THE NEW W. EDWARD BALMER SCHOOL

NORTHBRIDGE, MASSACHUSETTS

SCHOOL BUILDING COMMITTEE MEETING

APRIL 24, 2019

36" STORM DRAIN LINE – SD DESIGN OPTION 1

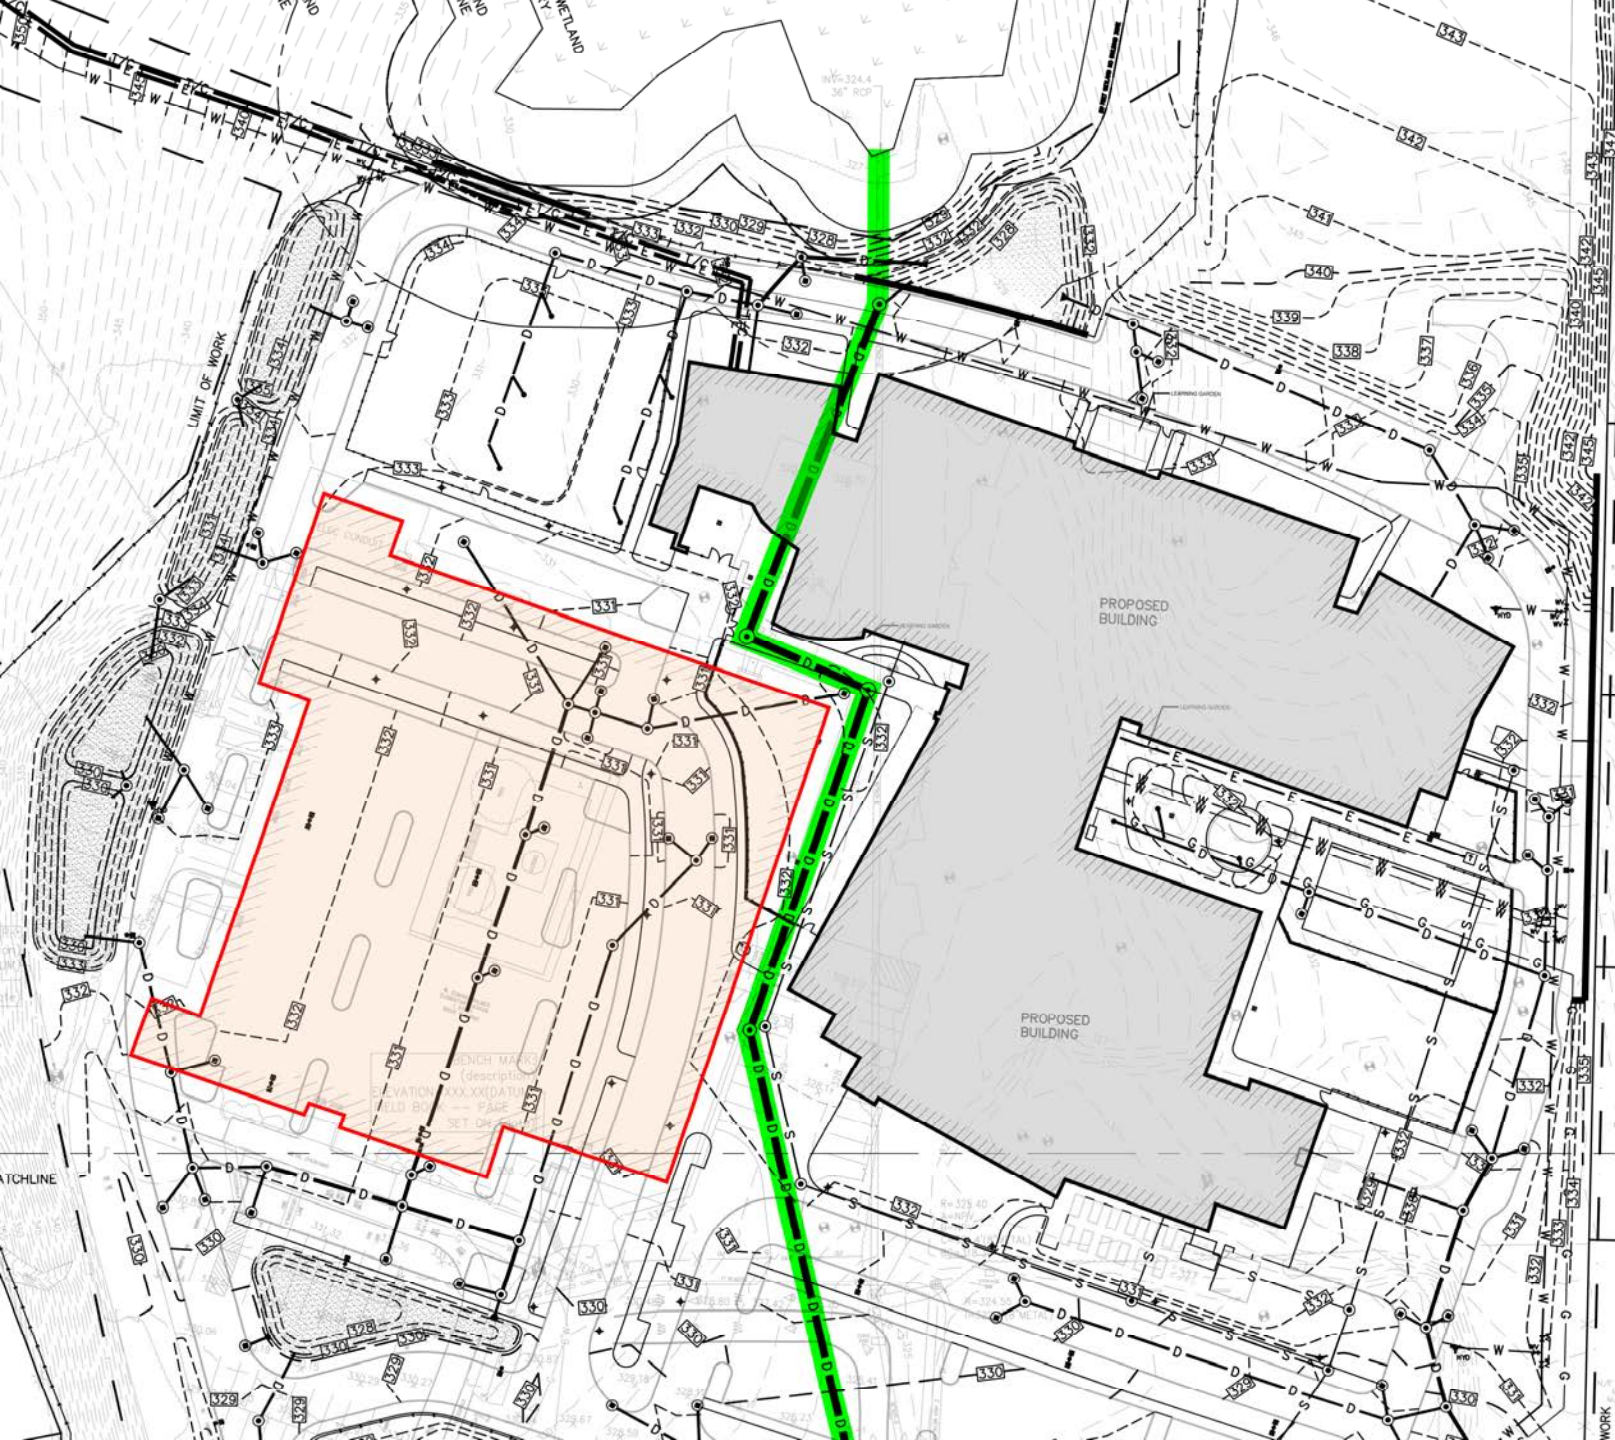
- Pipe shown as sketch to convey idea
- Rejected due to proximity and depth of excavation right next to existing building; would require shoring.
- Conflicts with new building foundations

36" STORM DRAIN LINE – SD DESIGN OPTION 1A

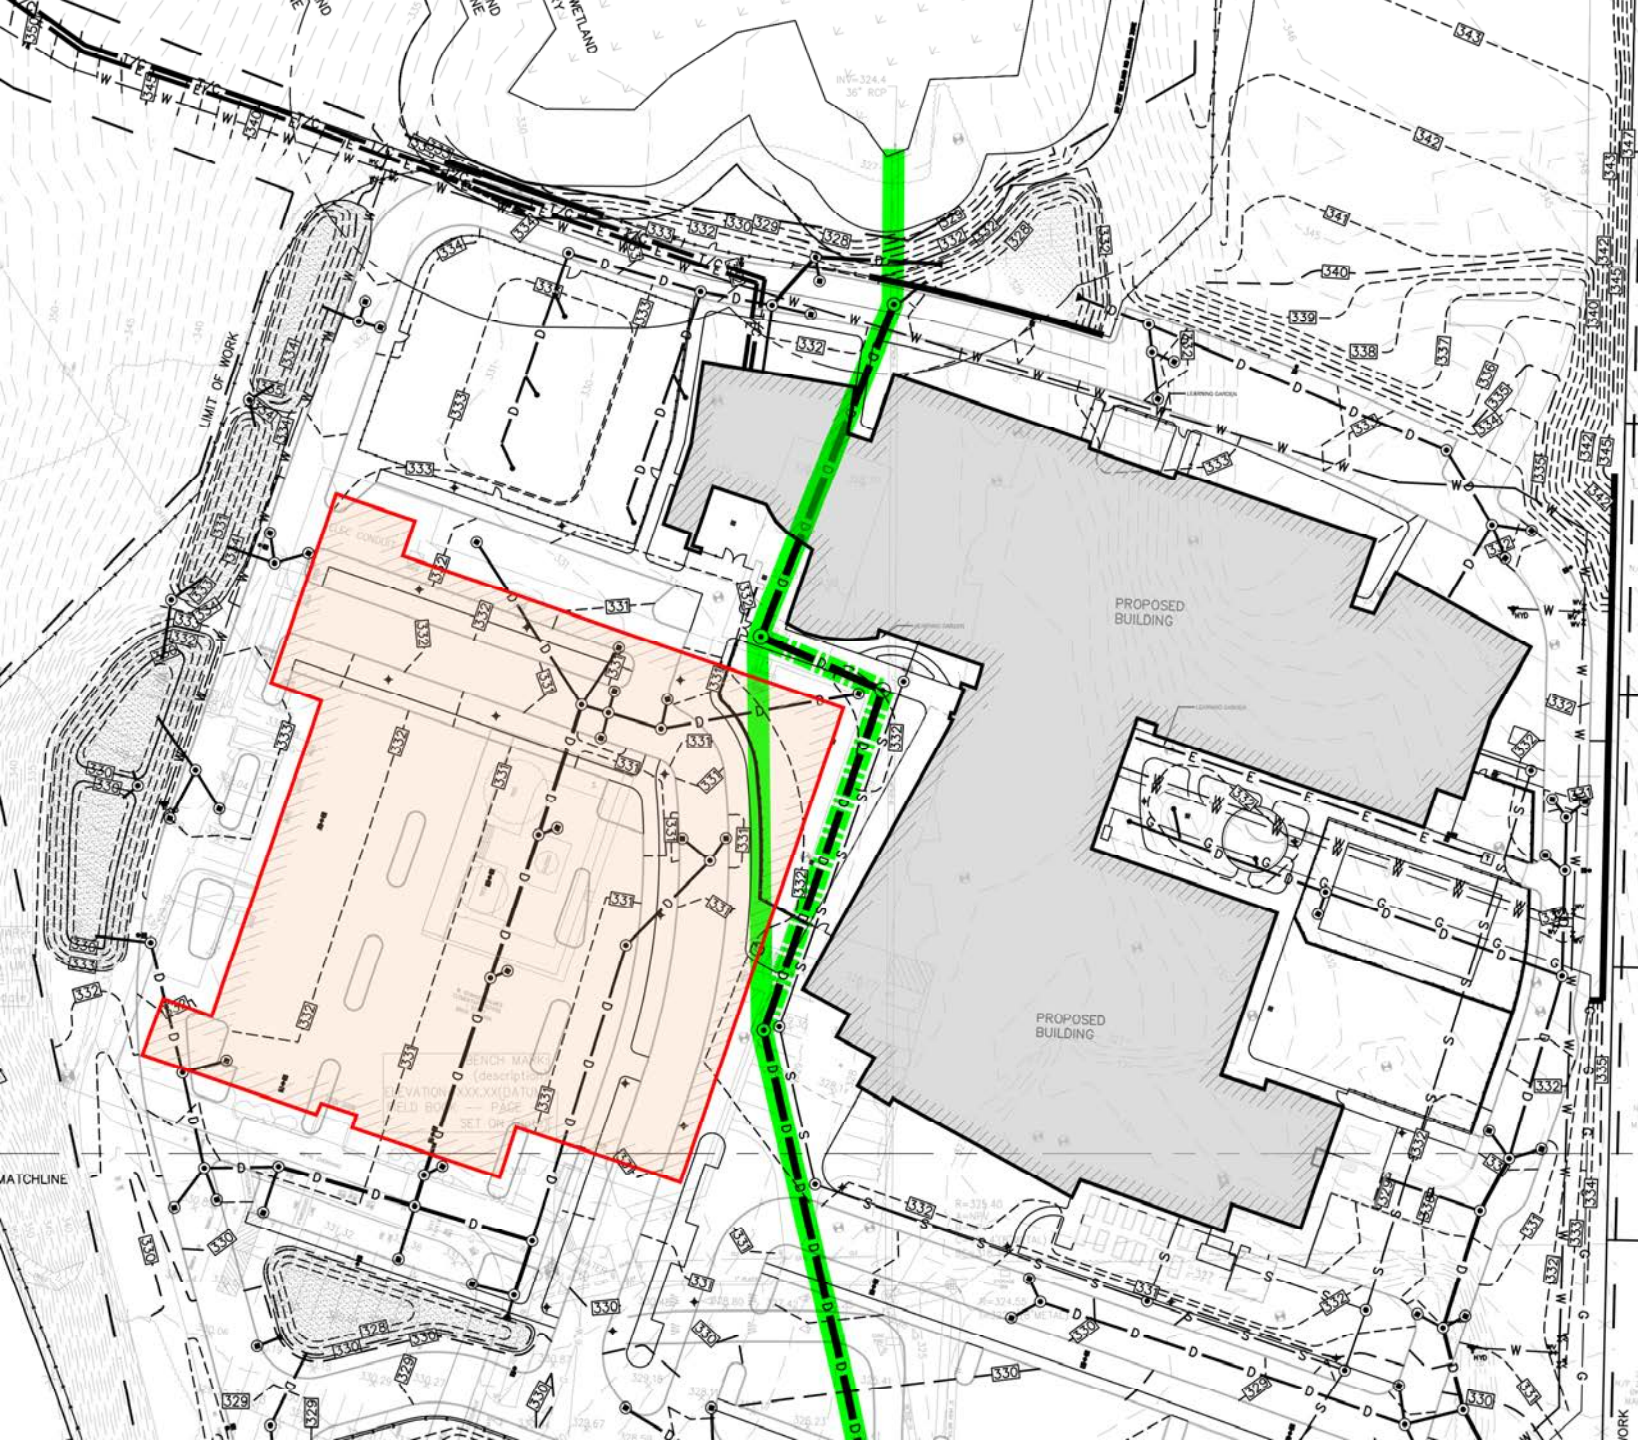
- Step 1 - temporary drain during construction (dashed line)
- Step 2 - Install permanent drain when existing building demo'ed
- Sequence and depth of excavation did not work with summer schedule for bus lane going on-line for Fall 2021

36" STORM DRAIN LINE – DD DESIGN OPTION 2

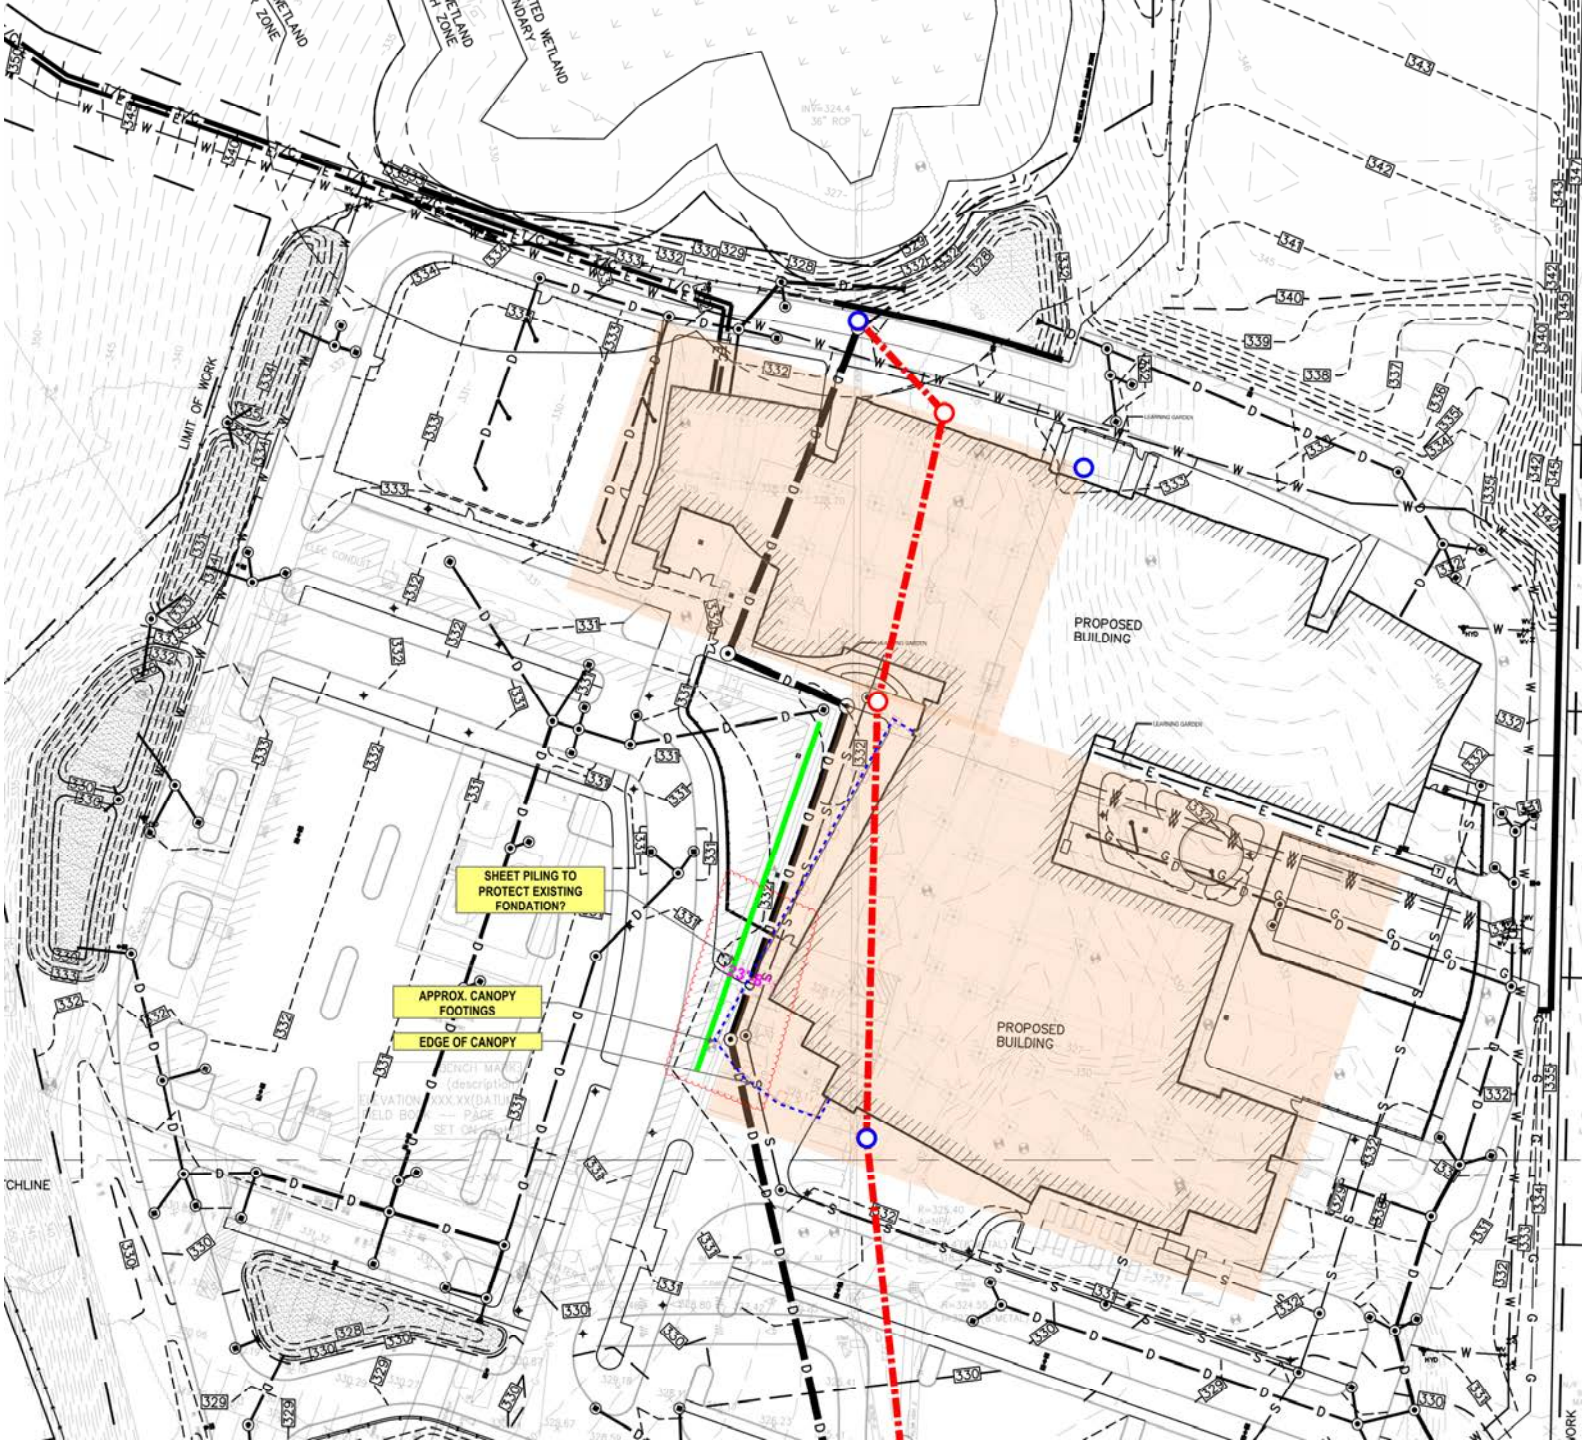
- Two-run drain pipe under A-Wing then C-Wing
- Rejected due to diagonal alignment to building geometry creating too much interference with foundations
- Also more beneficial for construction to be further away from the existing building

36" STORM DRAIN LINE – DD DESIGN OPTION 3

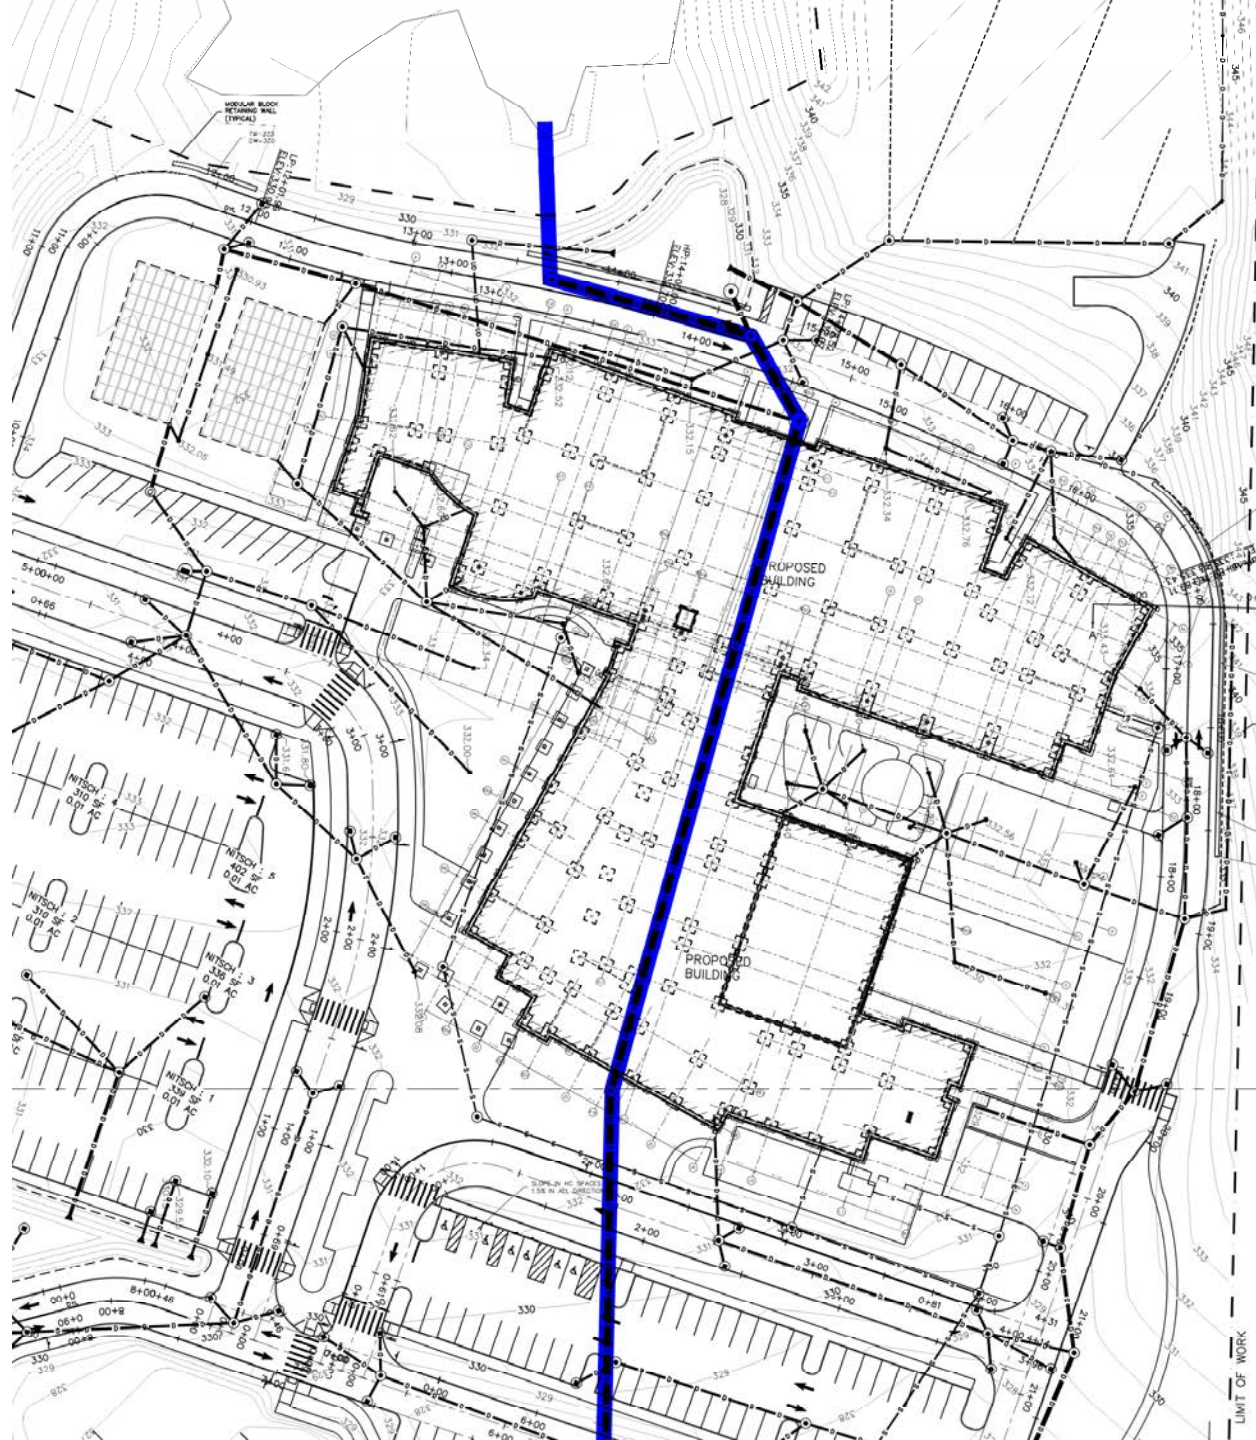
- Single-run drain pipe down the middle of the building
- Line of best fit, aligned well to building geometry with least amount of interference with foundations
- Beneficial for construction to be further away from the existing building
- **PREFERRED ALTERNATIVE**

#2 & 39 - TOILET ROOM PLAN – LAYOUT WITH ENTRANCE SPLIT

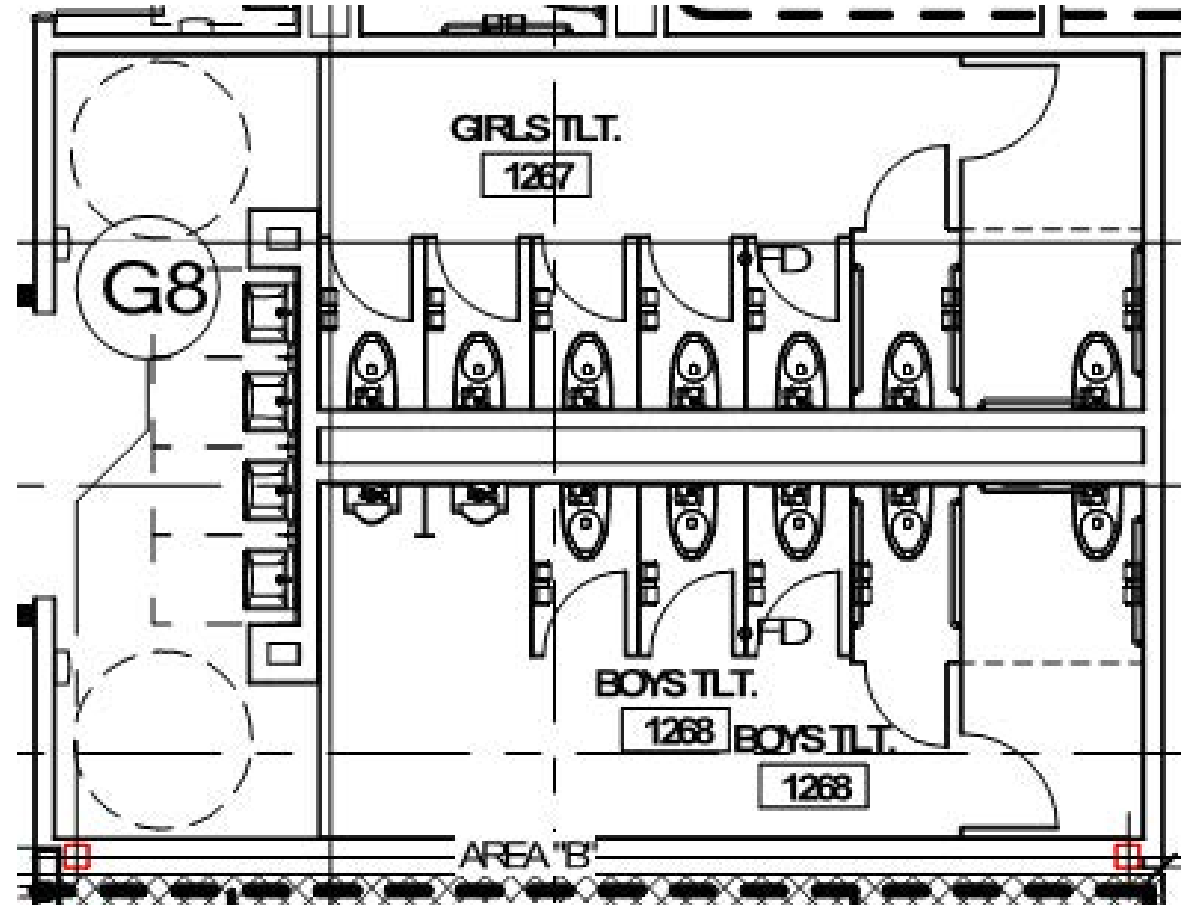
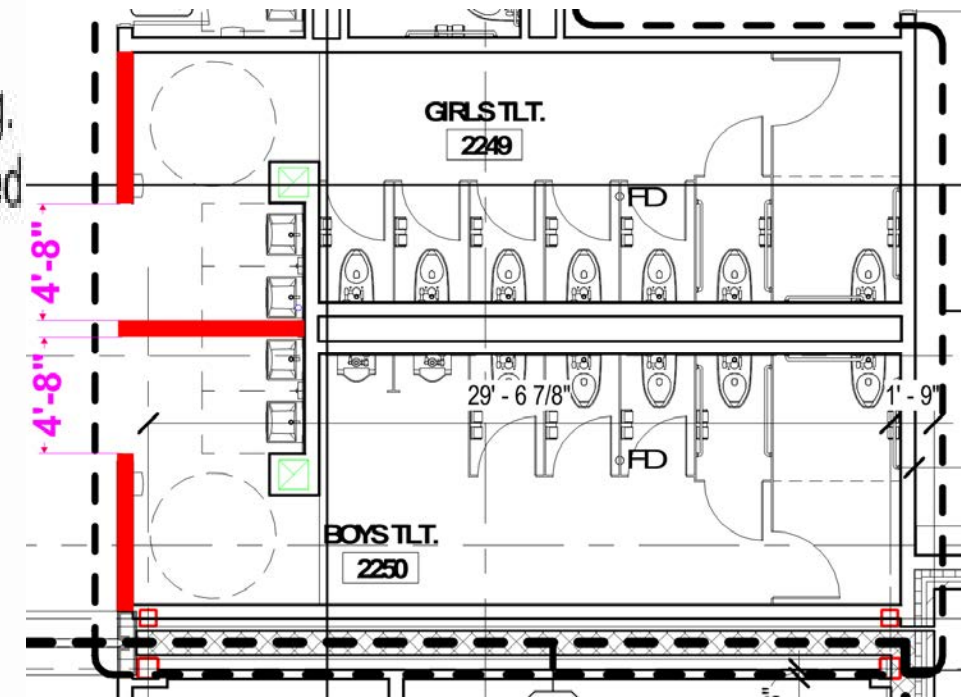
An assessment guide for school restrooms put together by the National Clearinghouse for Educational Facilities identifies these design features as characteristics that improve the safety and security of restrooms and address health concerns associated with hand washing. The document summarizes that sinks and hand dryers should be installed in publicly exposed areas to deter vandalism and encourage hand washing. Installing sinks within view of the corridor reduces the amount of time students are away from supervision. This increased supervision also reduces behavior issues such as harassment and bullying. The National Center for Education Statistics Indicators of School Crime and Safety: 2012 noted 11% of students who reported being bullied at school in 2011 said the incident occurred in a bathroom or locker room. The visual and auditory supervision provided by the proposed design will reduce the likelihood of these behaviors occurring at this age level and promote respectful behavior among students.

SBC requested divider partition at sinks (illustration)

Design Team Recommendation: Keep as designed.
